Project:
SHADOW ANALYSIS REVIEW
NO 10 ONSLOW AVE & 21C BILLYARD AVE
ELIZABETH BAY NSW
CLIENT: DARNLEY HALL PTY LTD

**Objection to a Development Application: D/2023/727 - Revised.
No.10, Onslow Avenue and No.21C, Billyard Avenue,
Elizabeth Bay - Residential Flat Building
Visual Impact Assessment Report: Revised Scheme, July 2024**

UPDATED FOR NEW PLANS

21C MERMAN OVERRUN

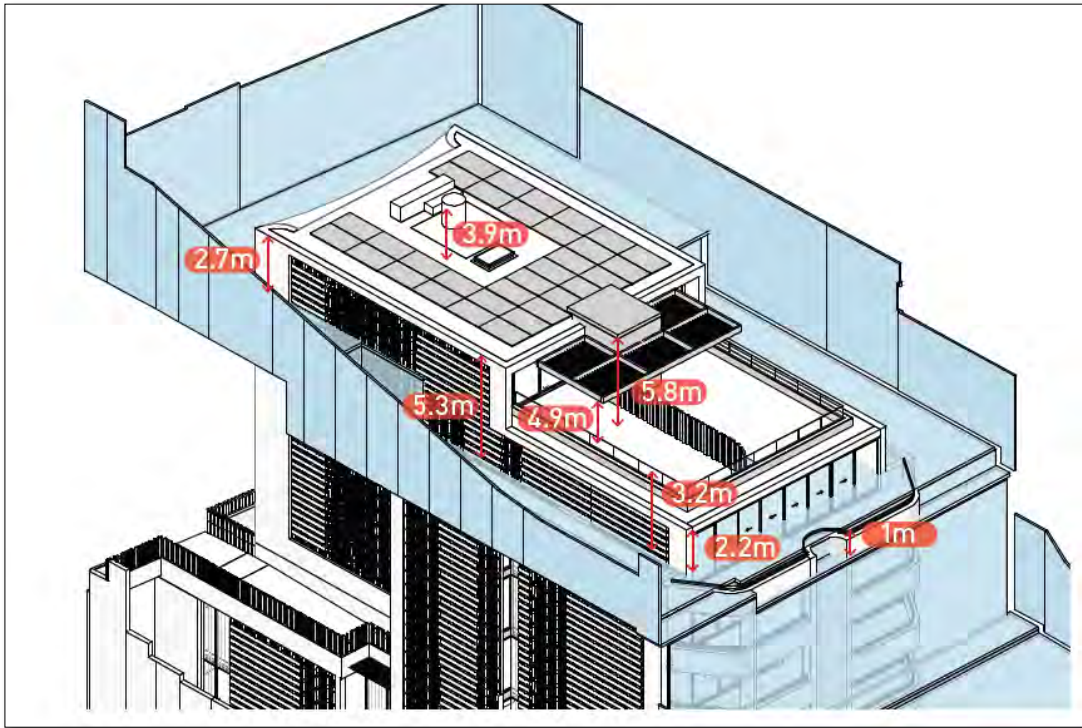
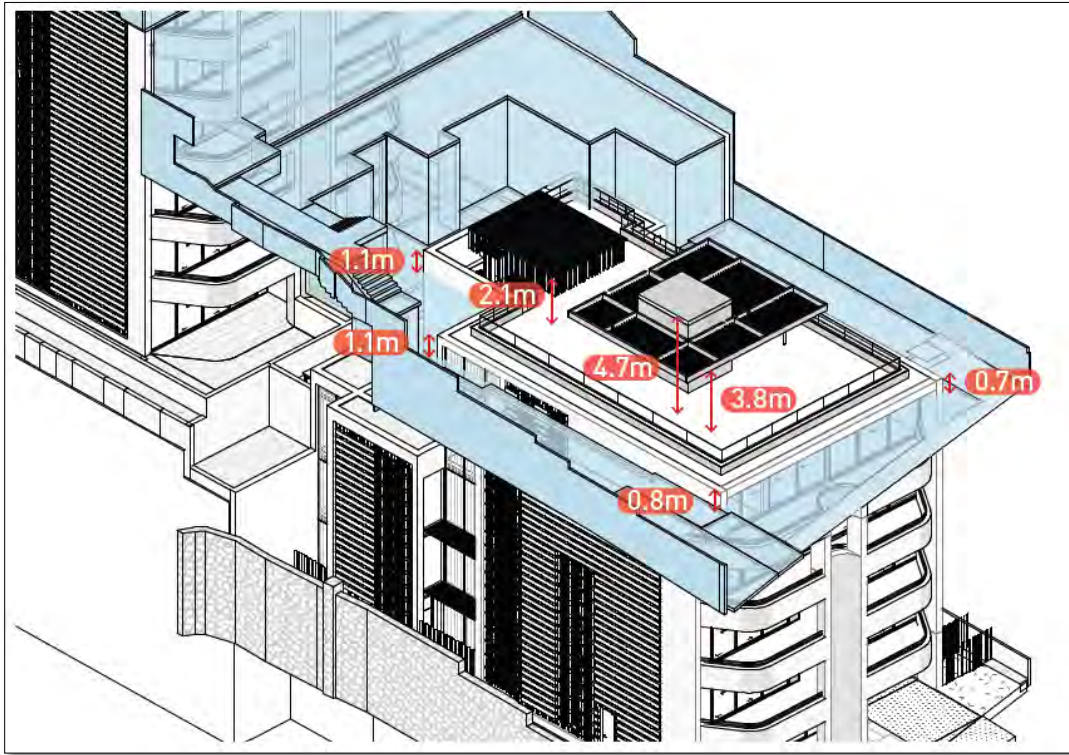
THEIR OWN ILLUSTRATION – TAB 3 PAGE 14 AND 15

HEIGHT OVERRUN CAUSING ADDITIONAL SHADOWING

The above illustration is for the winter solstice, but this additional floor will add shadow that moves up and down between the equinoxes, impacting an additional floor in our building.

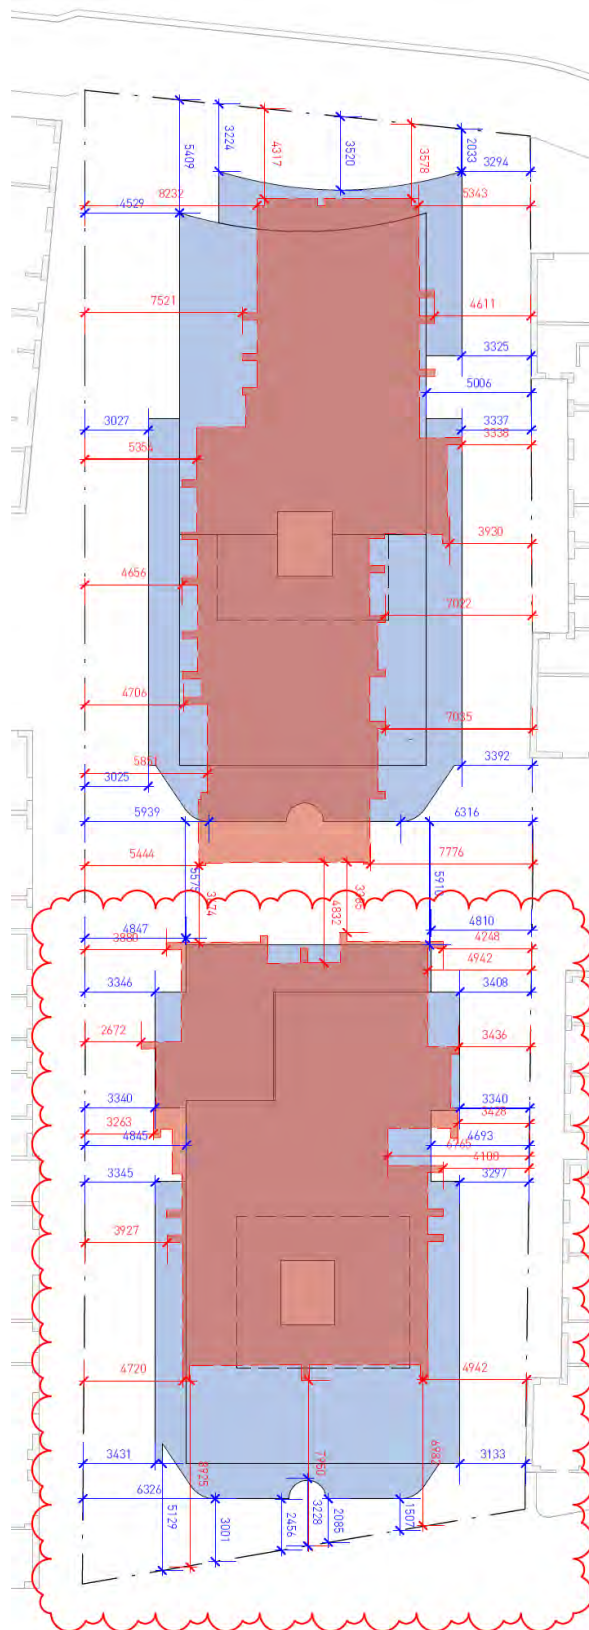
The same locality statement highlights that this area is characterised by “a landscape setting that allows view sharing to continue from the private domain and gaps between buildings’ (2.4.6). The new design changes next to nothing about the gaps between the buildings, and maintains a request for significant view loss (not sharing) for surrounding buildings. It still seeks to narrow the gaps between buildings in ways that further remove neighbourhood views, and makes the barest of efforts to trim the design on level 4 only.

Their own diagram, right, illustrates the difference to the starkest degree. Side setbacks reduced from 8.2m down to 4.5m, 5.3m to 3m, 7m, to 3.3m, and so on. These are intended to be the improved plans, and yet there is practically no difference.

The lack of contrast between the old and new plans can be seen in our Architect Drawing Comparison Appendix, attached.

UNIT 3

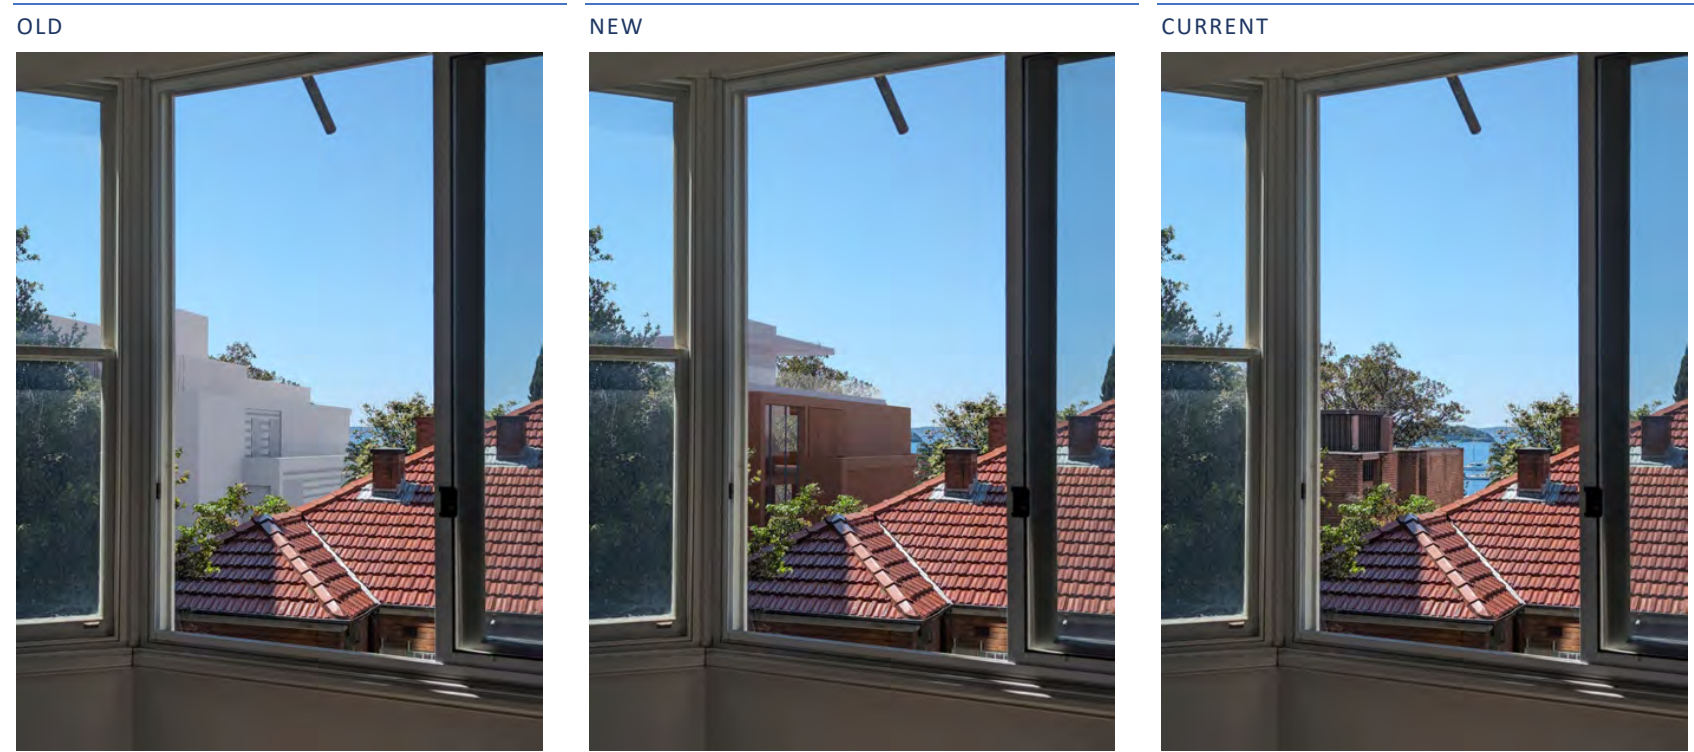
Please note that this view was not included for visual analysis in reporting provided for the DA. Urbaine Assessment: Moderate-to-Severe

1 DEMOLITION PLAN

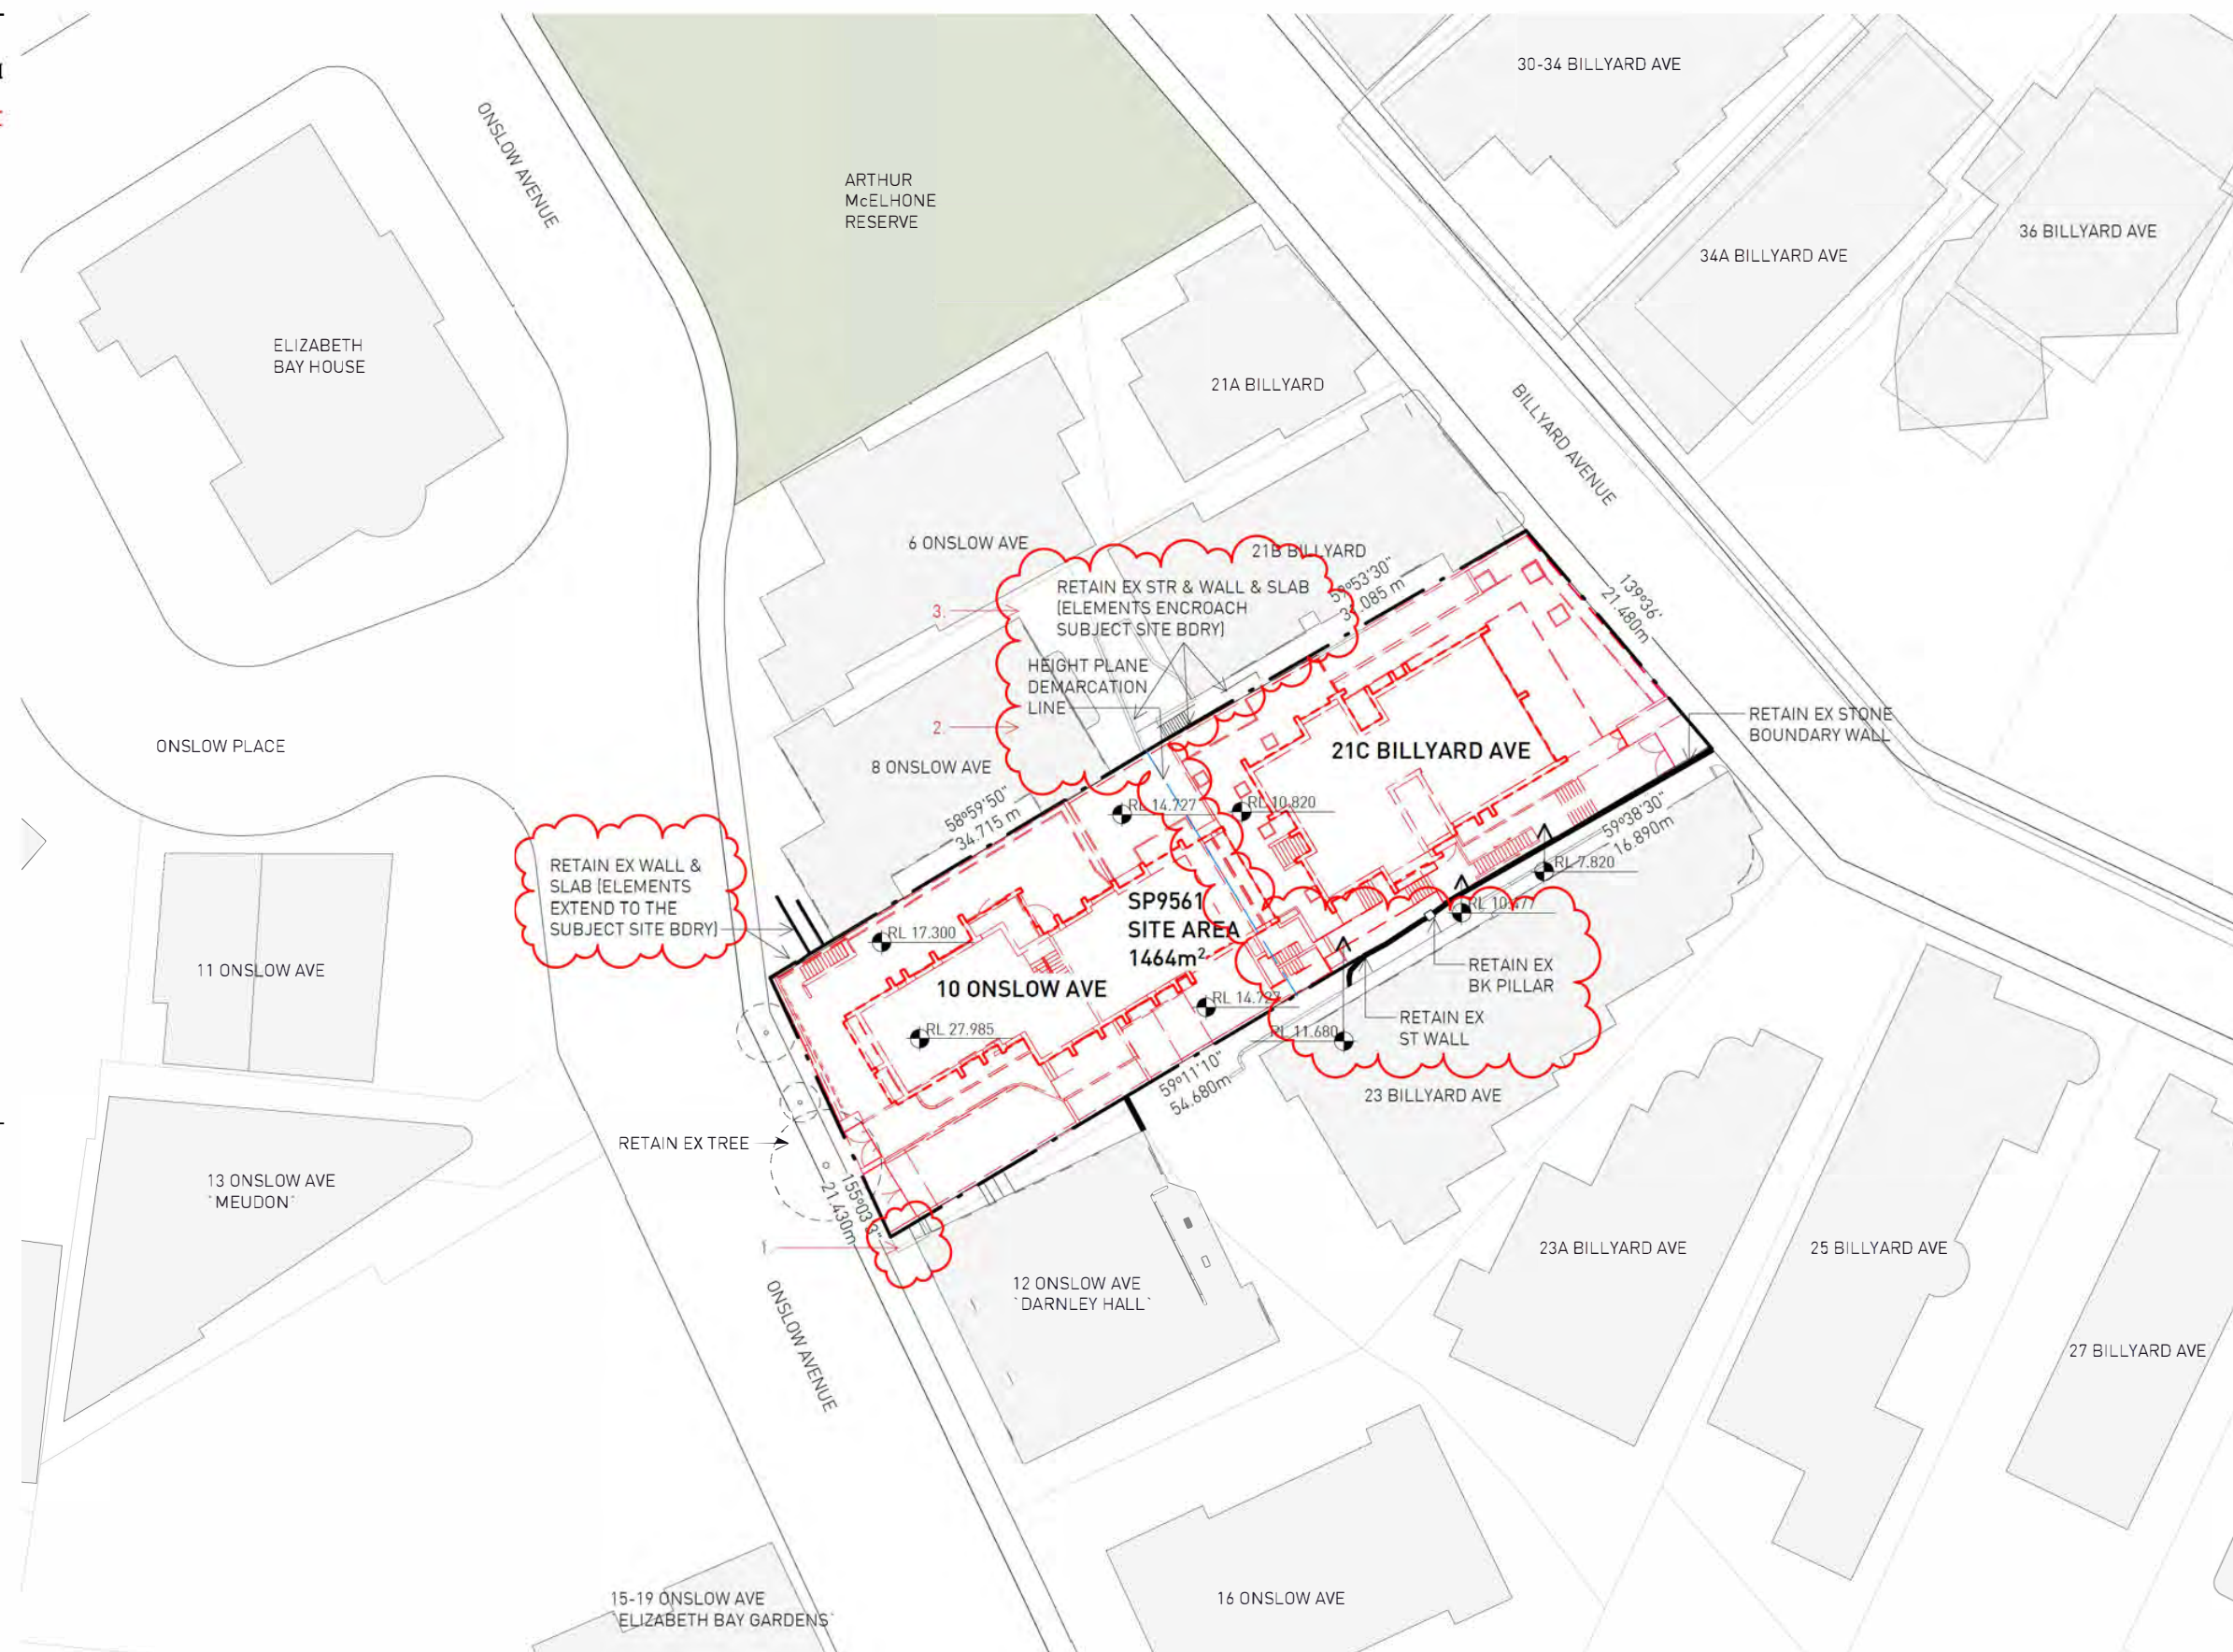
1. No demolition proposed outside subject site. Red dashed lines along 12 Onslow removed.
2. Height Plane demarcation line shown.
3. Neighbouring building elements that encroach onto the subject site, such as walls and stairs, will be retained.
